## Product Change Notification

CPTC RESETTABLE FUSES

### Bourns® Model CMF-xxxx-AP Ceramic PTC Resettable Fuses *Change to Packaging Method*

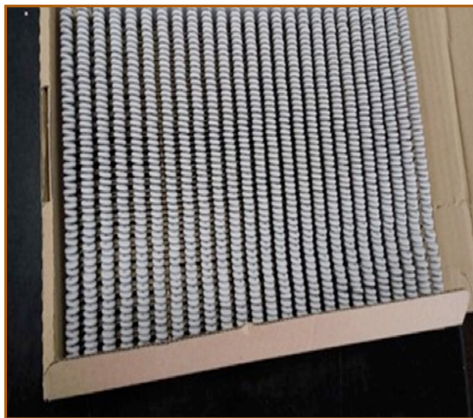
Effective immediately, Bourns is changing the packaging method for all [Model CMF-xxxx-AP](#) Ceramic PTC products which utilize an ammo packaging method (i.e., all CMF parts with the suffix “AP”). Bubble wrap is being added in-between each ammo layer to protect the part marking during transportation. The bubble wrap will help protect the products in the different layers from friction which could affect the marking on the parts.

The only change is adding bubble wrap in between each ammo layer with no change to the products themselves. There is no change to the form, fit, function, quality or reliability of the products.
